Re: Spring Creek North Continuation Project Information Request Response – Response 2 of 2

1 Request for Information Summary

This letter has been prepared to address the Department's request for information (RFI) to assess the application to amend environmental authority EPML00370013 (application reference A-EA-AMD-100430427), issued to Rolleston Coal Holdings Pty Ltd (RCH) on 19th July 2023.

Figure 1 Post Closure Scenario Analysis – All Voids Base Case Levels

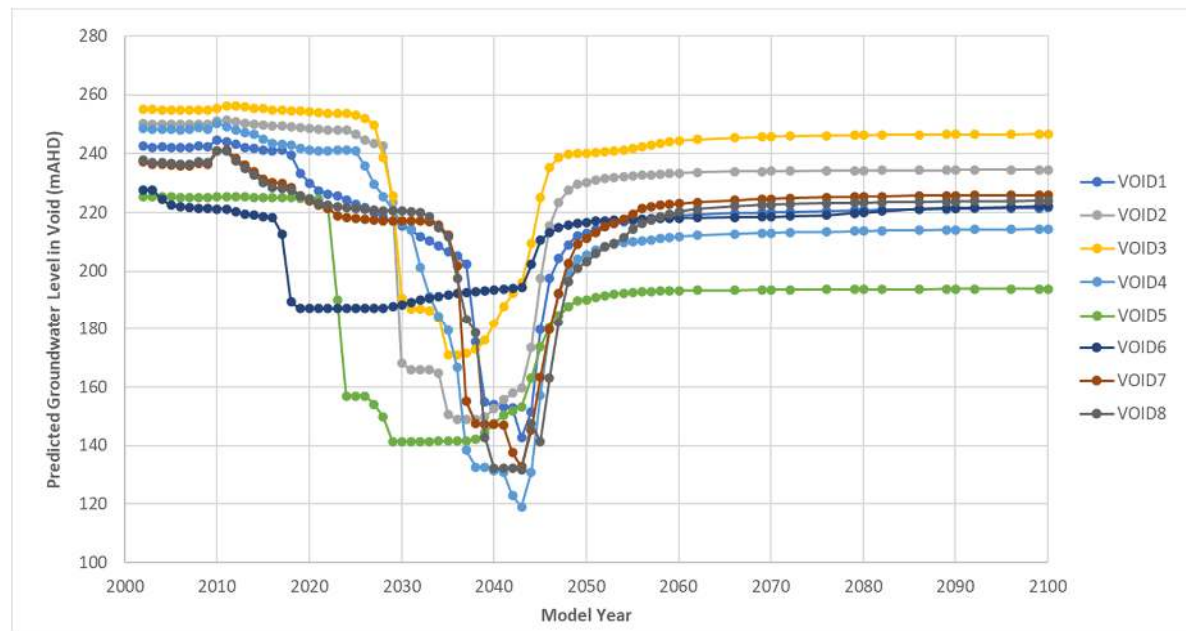
10	<p>Groundwater - Final Voids Modelling</p> <p>a) Appendix B, Section 5.5.1 states: "Recharge to the final voids was increased to 150% of annual rainfall to account for overland flow plus surface water diversion." However, it's unclear what surface water assessment was utilised to investigate and assess catchment size and run off to support the assumptions made.</p> <p>b) Section 5.3.10.2 of the supporting information document states: "Water quality within the final voids will change over time with groundwater inflows, spoil recharge and evaporative processes. However, as discussed in Section 5.3.5, unlike other areas in the Bowen Basin,</p>	<p>a) Justify using the figure of 150% and clarify the surface water assessment undertaken to support the final void modelling, including the proportion attributable to the proposed amendment.</p> <p>b) Provide an assessment of the water quality to remain in any final void/s.</p> <p>c) Present each void in figure 5.19 on an individual graph and compare to the predicted groundwater levels at each location.</p>	<p>a) A summarised Final Void Assessment has been prepared and is provided in Appendix D. A specific response to item 10 a) is provided on page 5 of Appendix D.</p> <p>b) A summarised Final Void Assessment has been prepared and is provided in Appendix D. A specific response to item 10 b) is provided on page 7 of Appendix D.</p> <p>c) Each void is presented with an individual graph in Umwelt (2023) Figure 5.25 to Figure 5.29 for the voids within the SCNCP. The graphs include the predicted groundwater levels in the void area under the base case scenario, plus the range in predicted groundwater levels in the void area for the sensitivity scenarios. Further details on all site voids within ROC are included in Section 2.2. Individual graphs for each site voids (Void 1 to Void 8) showing</p>

A graph showing the predicted groundwater elevation at each void area over time is also provided in **Figure 1**. Individual graphs for each void, showing the variability in predicted groundwater levels in the void areas for the sensitivity scenarios are shown in **Figure 2** to **Figure 9**.
